UNITED STATES ENVIRONMENTAL PROTECTION AGENCY

RE: Request for Information ("RFI") Pursuant to Section 308 of the Clean Water Act City of Middletown Municipal Separate Storm Sewer System ("MS4") (NYR20A271) Docket No. CWA-IR-15-018

Municipal Separate Storm Sewer System (MS4) Audit City of Middletown (NYR20A271) October 21, 2014 through October 23, 2014

RIMG0011.JPG – Unconnected washing machine in Water & Sewer Department Garage.

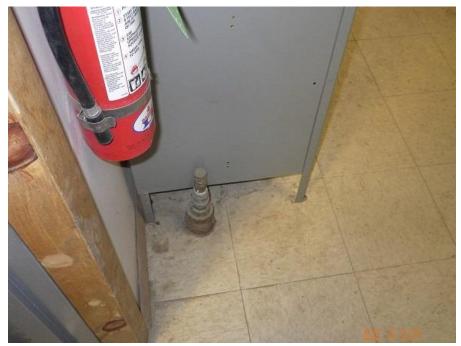
- 4. During the Audit, the City informed the EPA Audit team that it would move the washer from the Water & Sewer Department Garage bay to the locker room to minimize the potential for accidental discharge. Upon completion of move, the City stated it would inform EPA of status.
